MCPB
Item No. 1
11-20-03

PROJECT: MacArthur Boulevard Bike Path/Lane Improvements
From District of Columbia line to Old Anglers Inn

REVIEW TYPE: Project Prospectus

APPLYING FOR: Agency Comments

Vicinity Map and Selected Spot Improvements

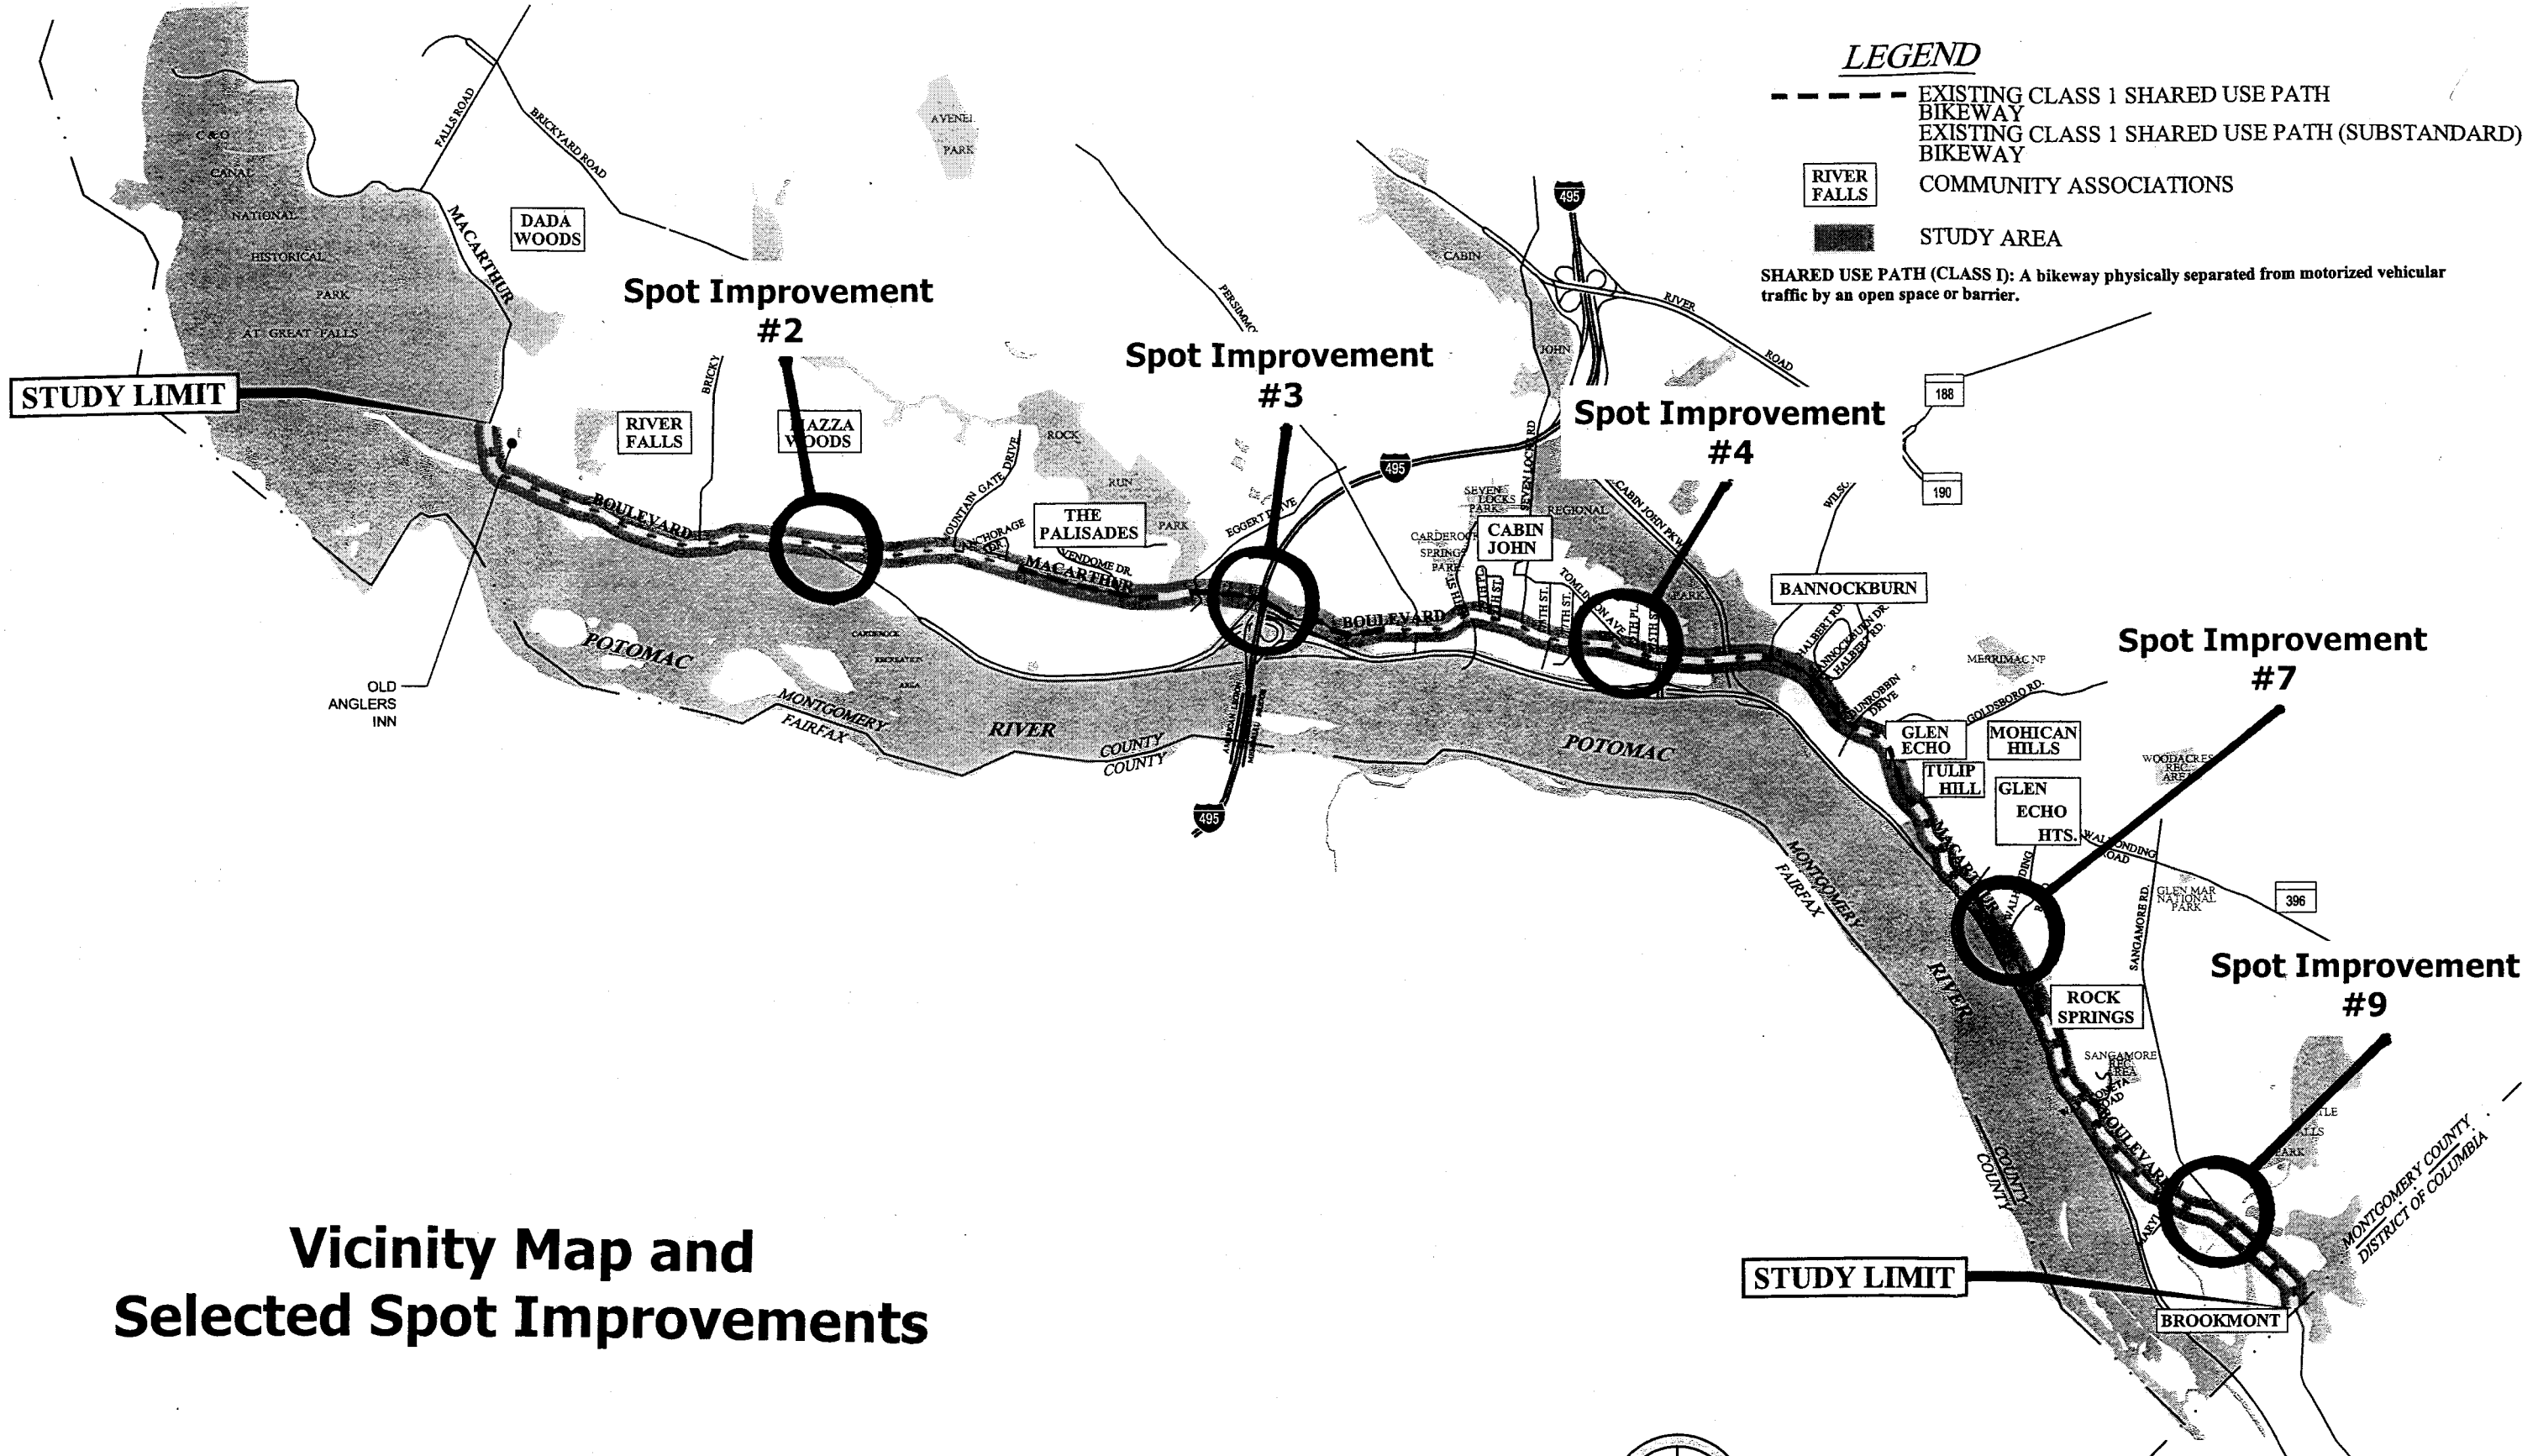
2. For all locations where spot improvements are recommended, the existing conditions should be described and located on a map, and the need for improvements should be explained. These comments pertain to particular locations (See Attachment 1: Vicinity Map and Selected Spot Improvements):

- a) At Spot Improvement #2, consider installing signs to warn motorists on MacArthur Boulevard of bicycle crossings at Clara Barton Parkway.
 - b) At Spot Improvement #3, provide a bike-safe barrier where a substandard landscape panel would exist under I-495.

- c) At Spot Improvement #4, identify as part of Alternative 2 some measures that would discourage patrons of Captain's Market from illegally parking on the shared use path.

- d) At Spot Improvement #7, ensure that crosswalks at the parking lot entrance and exit are well designed and marked. Also, ensure a landscape buffer is provided between the parking lot and the shared use path.

- e) At Spot Improvement #9, coordination with park path planners and DPWT traffic engineers will be required.
3. Provide the AASHTO-recommended vertical clearance of eight feet for the shared use path throughout the project length.
